United States Department of the Interior
NATIONAL PARK SERVICE

February 14, 2001

RE: Draft Environmental Impact Statement for the Southern Ute Reservation Oil and Gas Development, San Juan NM, Montezuma, La Plata, Archuleta Counties, CO.

The National Park Service has reviewed the aforementioned DEIS and has the following comments:

Figure 1. Plot of annual average particulate species at the Mesa Verda National Park

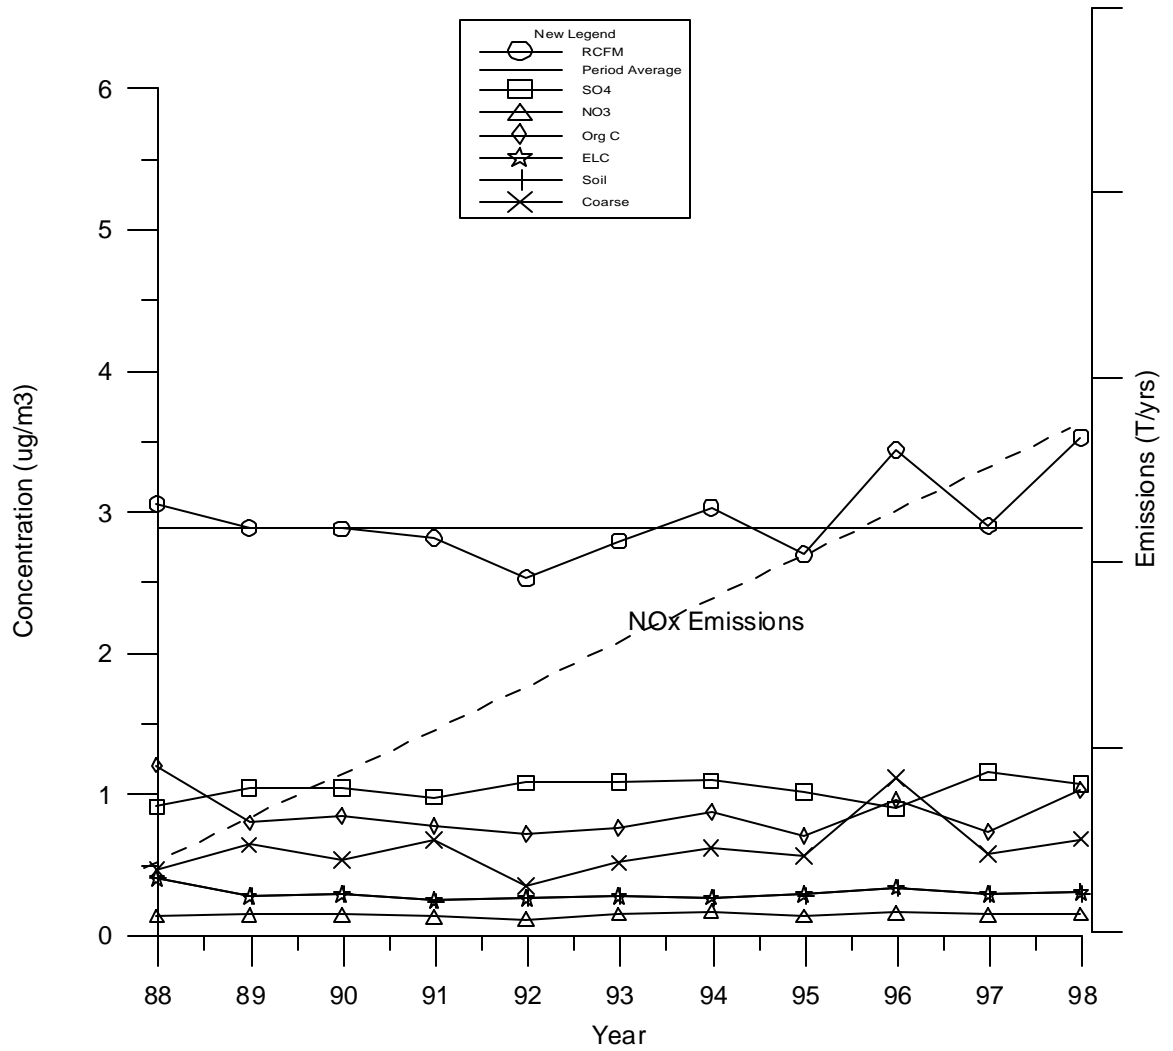
Based on this empirical information that correlates NO_x emissions to changes in NO₃ levels, NO_x control strategies may have little benefit to overall air quality levels in these two Class I areas. This is compelling data that supports the issuance of a ROD with an emission limit of not less than 2 g/hp-hr.
